<b>Subject:</b>  <b>RATTLE NOISE FROM TURBOCHARGER WASTEGATE ACTUATOR ARM DURING ACCELERATION AND IDLING</b>	<b>Bulletin No.:</b> 01-013/24
	<b>Last Issued :</b> 12/11/2024

2024 CX-50 (2.5L Turbo) with VINS 7MMVA\*\*\*\*\*202832 to 244889 (produced between February 24, 2024 and July 23, 2024)

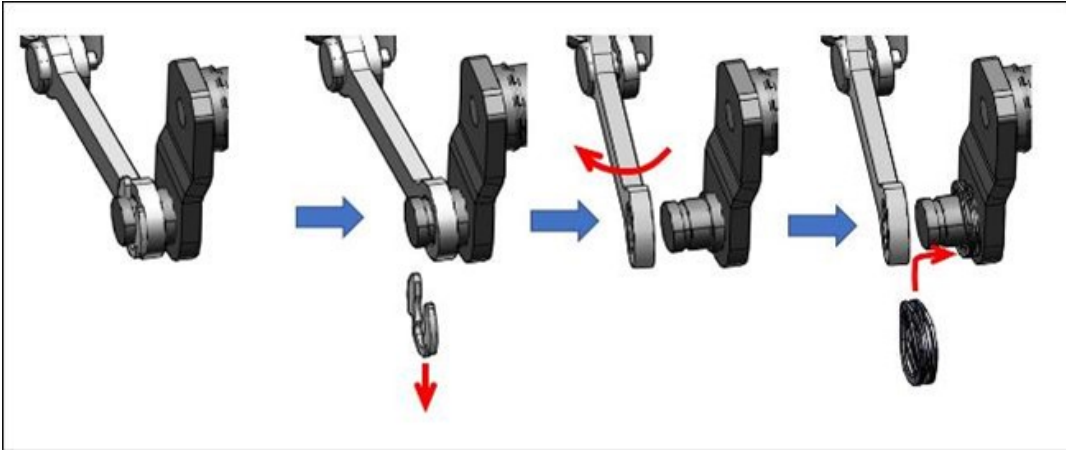
Some customers may complain about a rattle noise coming from the engine compartment when accelerating or idling. This may be caused by play at the turbocharger wastegate pivot arm creating a rattle-type noise. To eliminate this concern, a wave washer has been added.

1. Verify the customer's concern.
2. Replace the turbocharger wastegate valve spring as follows.
  - a. Disconnect the exhaust and remove the propeller shaft (See PROPELLER SHAFT REMOVAL/INSTALLATION).  
**NOTE:** Place rags over the catalytic converter, PTO, and around the work area in case the E clip or spring washer is dropped.
  - b. While reaching between the engine and subframe, carefully insert and twist a small flat-blade screwdriver between the E clip and pivot to remove the E clip (using a rag to catch the E clip when it detaches from the pivot).

- c. Gently lower the wastegate actuator pivot rod from the wastegate pivot.

d. Install the new spring washer over the step on the pivot.

e. Install the wastegate actuator arm onto the pivot.

f. While gently depressing the spring washer, carefully install the new E clip into the pivot arm groove.

g. Using pliers, squeeze the E clip until it is fully seated in the pivot groove.
